RIVERVIEW SUBDIVISION, RESUBDIVISION OF LOTS

6 – 9, BLOCK 1

APPLICATION NUMBER 17 DATE July 16, 2009

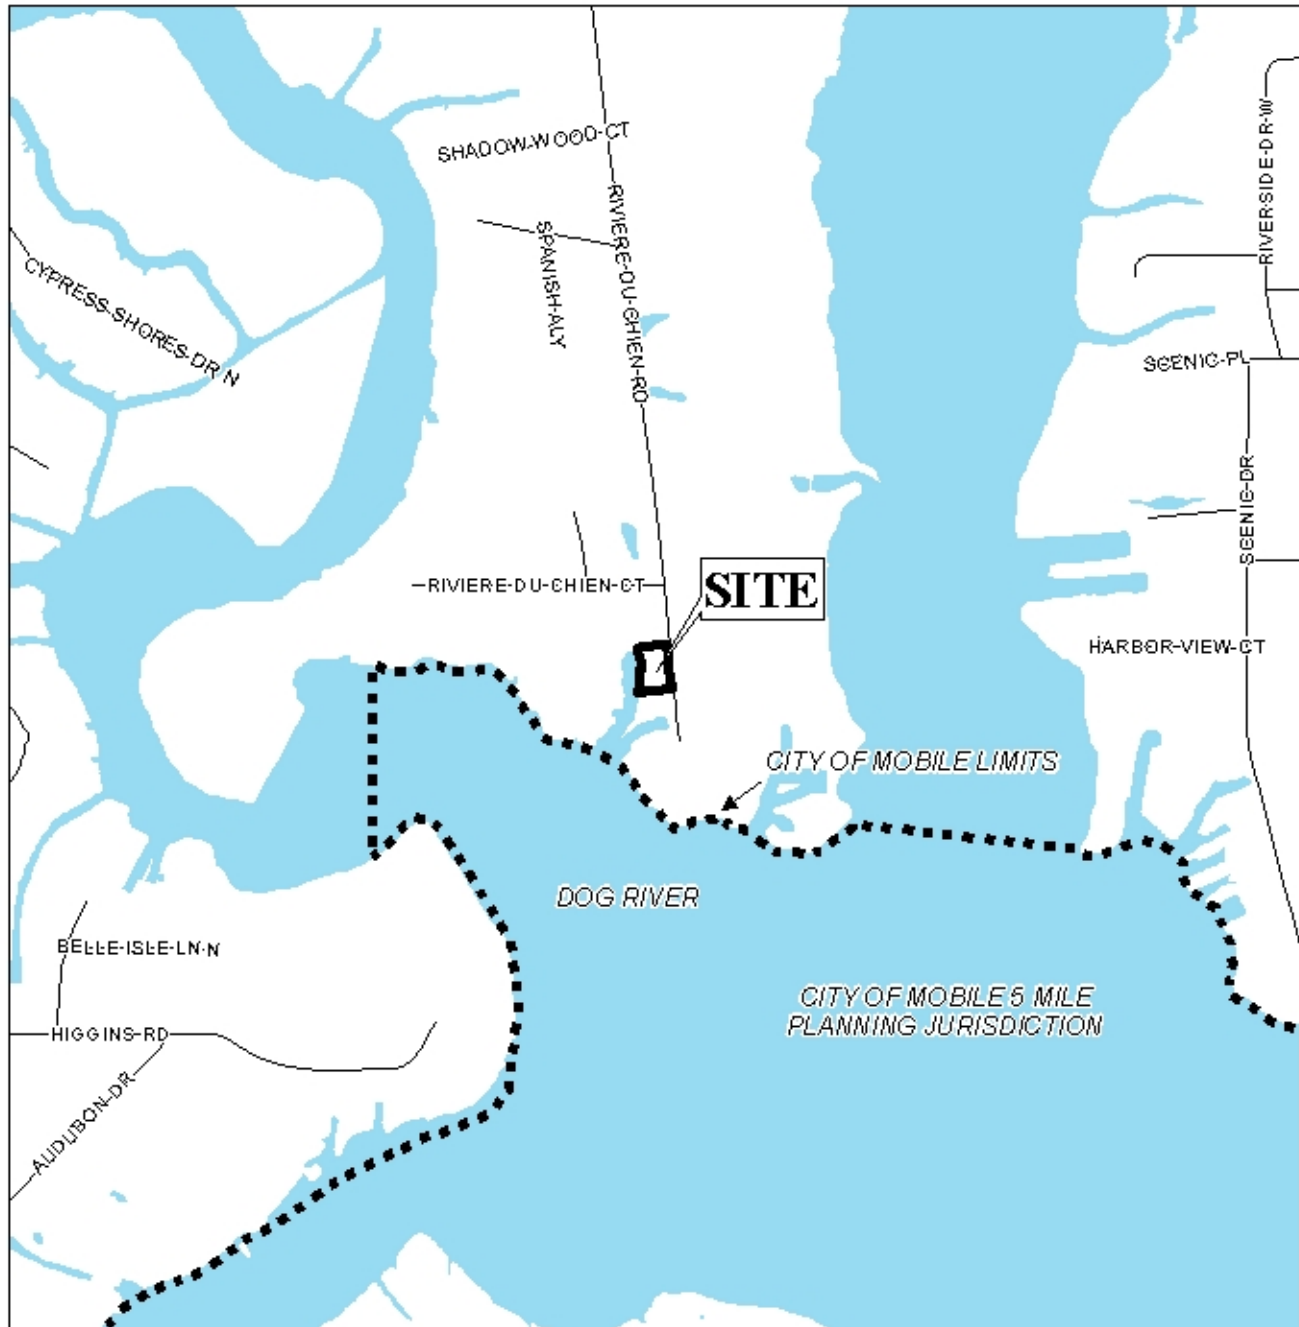
Engineering Comments: Show Minimum FFE on each lot shown on plat. Fill is not allowed without City of Mobile Engineering Department approval, which at a minimum requires providing compensation or completing a flood study. Wetland locations must be shown on plat. Any work in wetlands must be permitted through the Corps of Engineers and copies of permits must be provided the City prior to obtaining Land Disturbance Permits. Must comply with all storm water and flood control ordinances. Any work performed in the right of way will require a right of way permit.

Traffic Engineering Comments: Driveway number, size, location, and design to be approved by Traffic Engineering and conform to AASHTO standards.

City GIS information indicates a portion of a public right-of-way along the West end of the current Lot 6, Block 1, Riverview Subdivision, and extending North across the adjacent property to Riviere du Chien Court. As this was indicated as an unopened public right-of-way on the GIS data until the late 1990's and is still indicated as such on City Real Estate Department maps, but is now indicated to be privately owned, documentation should be submitted to verify vacation of the right-of-way or an error in the mapping prior to signing the final plat.

The proposed subdivision fronts Riviere du Chien Road with a compliant 50' right-of-way; therefore, no dedication would be required. As a means of access management, a note should be required on the final plat stating that each lot is limited to one curb cut, with the size, location, and design to be approved by Traffic Engineering and conform to AASHTO standards. The plat should be revised to illustrate the 25' minimum building setback line along Riviere du Chien Road. As on the preliminary plat, each lot should be labeled with its size in acres and square feet, or a table should be furnished on the final plat providing the same information.

The site is bounded to the West by a canal, and as illustrated on the Environmental GIS database, NWI wetlands exist on a portion of the site. The presence of wetlands indicates that the area may be environmentally sensitive; therefore, if approved, the approval of all applicable federal, state and local agencies would be required prior to the issuance of any permits or land disturbance activities.

The plat meets the minimum requirements of the Subdivision Regulations and is recommended for Tentative Approval, subject to the following conditions:

- 1) submission of documentation to verify vacation of the unopened public right-of-way along the rear portion of current Lot 6, Block 1, Riverview Subdivision, or submission of evidence of a City mapping error, prior to signing the final plat;

- 2) placement of a note on the final plat stating that each lot is limited to one curb cut, with the size, location, and design to be approved by Traffic Engineering and conform to AASHTO standards;

- 1) illustration of the 25' minimum building setback line along Riviere du Chien Road;
- 2) labeling of each lot with its size in square feet and acres, or the furnishing of a table on the final plat providing the same information;

- 3) placement of a note on the final plat stating that the approval of all applicable Federal, state and local agencies would be required prior to the issuance of any permits or land disturbance activities;

- 4) placement of a note on the final plat stating that development of this site must be undertaken in compliance with all local, state and Federal regulations regarding endangered, threatened or otherwise protected species; and

- 5) subject to the Engineering Comments: *(Show Minimum FFE on each lot shown on plat. Fill is not allowed without City of Mobile Engineering Department approval, which at a minimum requires providing compensation or completing a flood study. Wetland locations must be shown on plat. Any work in wetlands must be permitted through the Corps of Engineers and copies of permits must be provided the City prior to obtaining Land Disturbance Permits. Must comply with all storm water and flood control ordinances. Any work performed in the right of way will require a right of way permit).*
